05-26-2021 Town Council Meeting Responses to Council Questions

ITEM #8: Continue the Public Hearing: Application for Conditional Zoning - Aura Development, 1000 Martin Luther King Jr. Blvd.

**C-5179 - ESTES DRIVE
 BICYCLE & PEDESTRIAN
 IMPROVEMENTS**

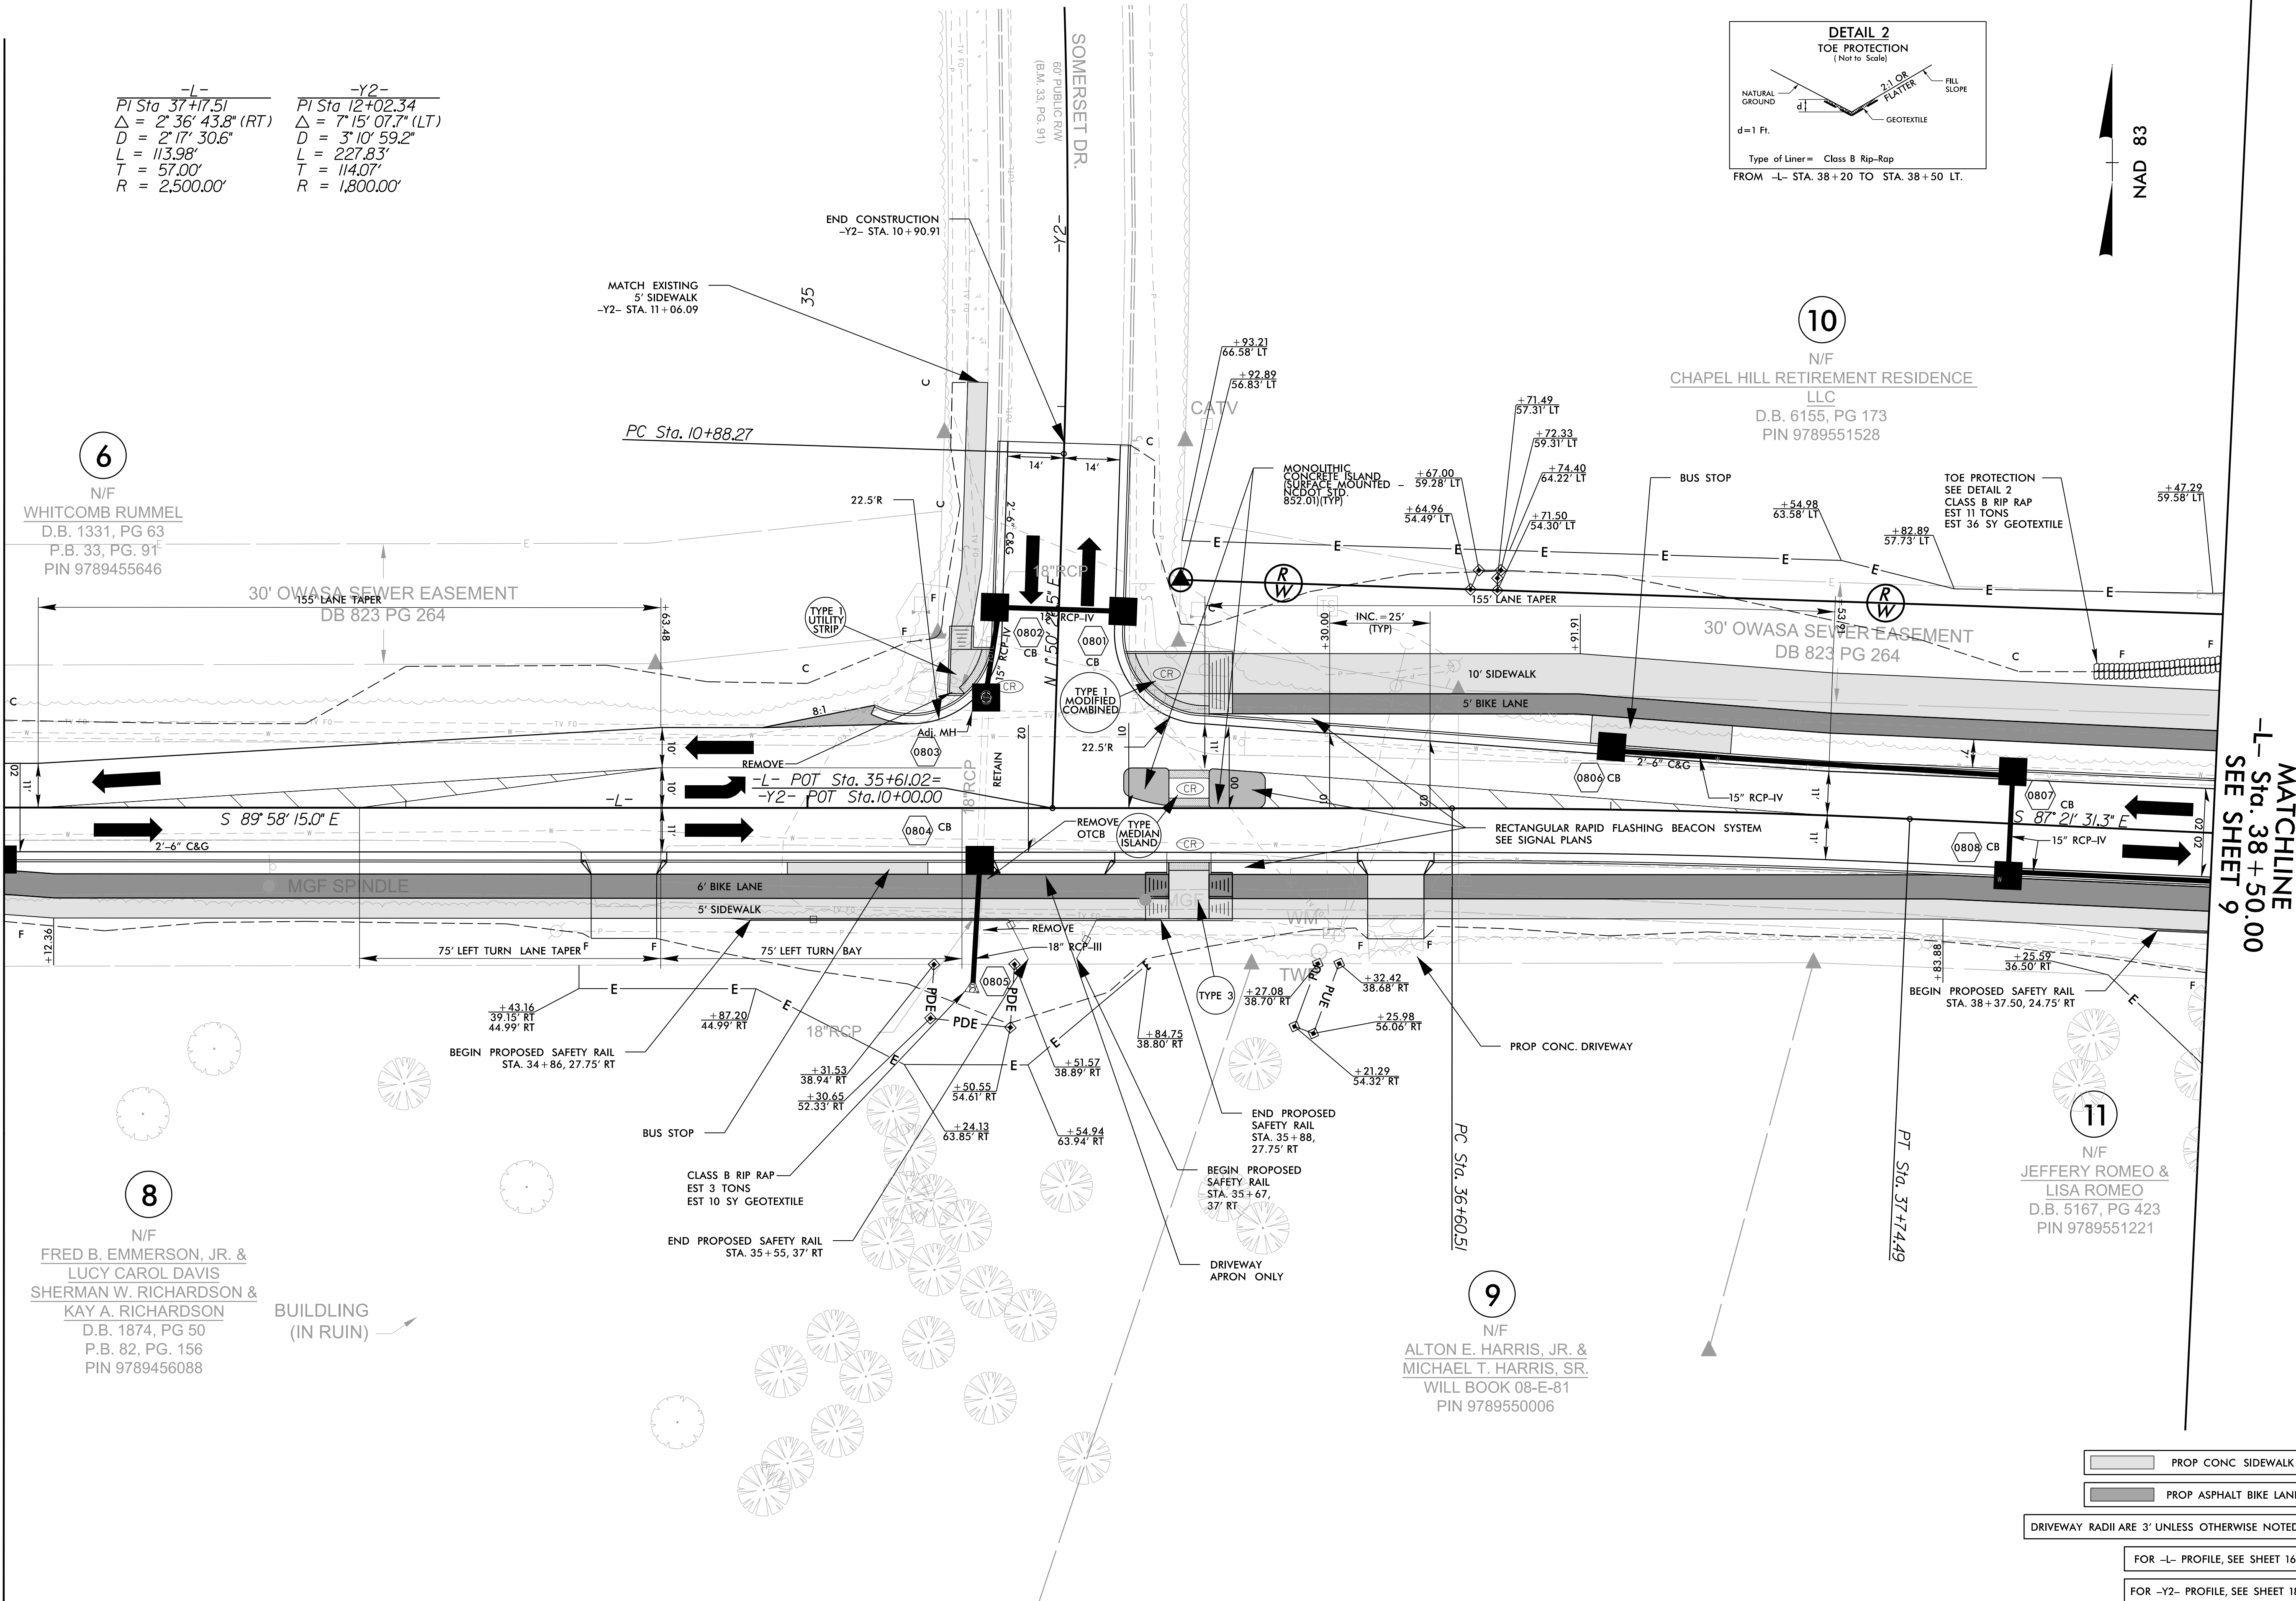
The Estes bike/ped project specifies a general design of 7' planting strip, 5' bike lane, and 10' sidewalk for the north side of Estes east of Somerset.

- a. Why did staff not include specific specs for the Aura/Rummel property frontages in the Estes project design?
- b. Why did the Aura team choose a different street frontage layout--5' planting strip, 6' bike path, 5' sidewalk, per the applicant's written response dated May 20--instead of matching the dimensions east of Somerset?
- c. The road section on page 63 of the packet shows a 2' planting strip, 5' bike path, and 10' sidewalk on the north side of the road at the Estes/MLK intersection. Is this drawing incorrect?

- a. *The Estes Drive Bike-Ped project does not include design for the Aura or Rummel properties because of difficulties with acquiring necessary right-of-way and easements on the required project timeline. Staff comments throughout the Aura review process have instructed the applicant to coordinate with the staff working on the Estes Drive Bike-Ped Improvements for consistency in design.*

- b. *The Aura frontage should match the typical cross section for the rest of the corridor – 10' multiuse path, 5' bike lane, 7' planting strip.*
- c. *The road section on page 63 was initially created for a Town resident with questions about lane numbers and widths at the intersection of MLK/Estes. Staff focused on providing accurate dimensions for the transportation facilities (vehicular lanes, bike-ped facilities) and not on the planting strips or building setbacks/heights. We apologize for the confusion.*

The town's design criteria for the ped/bike facilities on Estes end at Somerset Drive. In order to provide a legible environment at the corner, the dimensions for the Aura frontage on Estes Drive are similar to (although slightly less urban than) the dimensions on MLK Blvd at the corner, to provide a consistent design. The bike/ped dimensions become more suburban along the Estes Drive frontage at the Woodlands to provide a transition to a more suburban condition. This provides a transition from the transit-oriented development at the corner to the adjacent schools and suburban residential developments. Also, we have matched the proposed design on the south side of Estes.

- a. *To our understanding, the NCDOT grant did not include the Aura/Rummer property.*
- b. *We have in fact matched the dimensions of the path/sidewalk/planting strip that are shown on the Town's construction drawings for the portion that they will build on the south side of Estes directly across from the Aura frontage. Please see the attached "Estes South side path plan from TOCH" which shows what the Town is proposing.*
- c. *Aura will provide a minimum 5' verge (planting area) along Estes Drive for the entire length of the Estes Drive frontage. We believe that The Woodlands area is the appropriate location for the transition to a more suburban design.*
